Access Compliance Report

Public Rights-of-Way

(Curb Ramps)

Intersection ID: 4075	Main Street: OVERLOOK_MOUNTAIN_DR	Cross Street: MOUNTAIN_COVE_DR	Location:	N
ADA ID: 1088E8B07F10	Ramp Type: Perp	Initial Pass/Fail: Fail	Overall Compliance: No	Severity Score: 1.25
Codes/Mitigation Info/Possible Solution		Field Measurements/Component Compliance

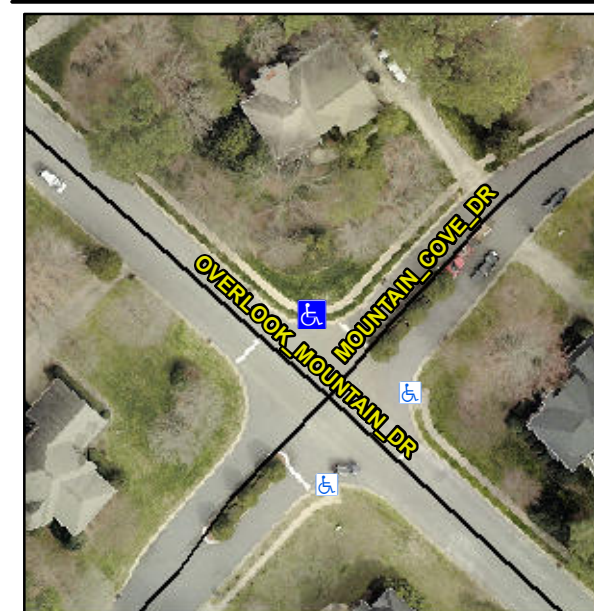
Not Found, R304.5.3

Compliance	Description	Data	Compliance	Description	Data
N/A	Ramp Length (in)	97.0	Yes	Ramp Slope (%)	5.8
Yes	Ramp Width (in)	49.0	No	Ramp XSlope (%)	4.1
N/A	Flare Type LT	N/A	N/A	Flare Type RT	N/A
N/A	Flare Slope LT (%)	N/A	N/A	Flare Slope RT (%)	N/A
N/A	Flare Traversable LT?	N/A	N/A	Flare Traversable RT?	N/A
N/A	Landing Length (in)	N/A	N/A	DWS Provided?	N/A
N/A	Landing Width (in)	N/A	N/A	DWS Contrast?	N/A
N/A	Landing Slope (%)	N/A	N/A	DWS Length (in)	N/A
N/A	Landing X Slope (%)	N/A	N/A	DWS Full Width?	N/A
N/A	Landing Curb? (Y/N)	N/A	N/A	DWS Offset (in)	N/A
N/A	Shared Landing?	N/A			
N/A	Gutter Ponding?	N/A	N/A	Gutter Slope (%)	N/A
N/A	Gutter Lip Ht (in)	N/A	N/A	Gutter X Slope (%)	N/A
N/A	Painted X Walk1?	No	N/A	Painted X Walk2?	N/A
	X Walk 1 Direction	To SE		X Walk 2 Direction	N/A
N/A	X Walk 1 Width (in)	N/A	N/A	X Walk 2 Width (in)	N/A
	X Walk 1 Slope (%)	5.4		X Walk 2 Slope (%)	N/A
	X Walk 1 X Slope (%)	0.5		X Walk 2 X Slope (%)	N/A

Remove & Replace Entire Ramp.
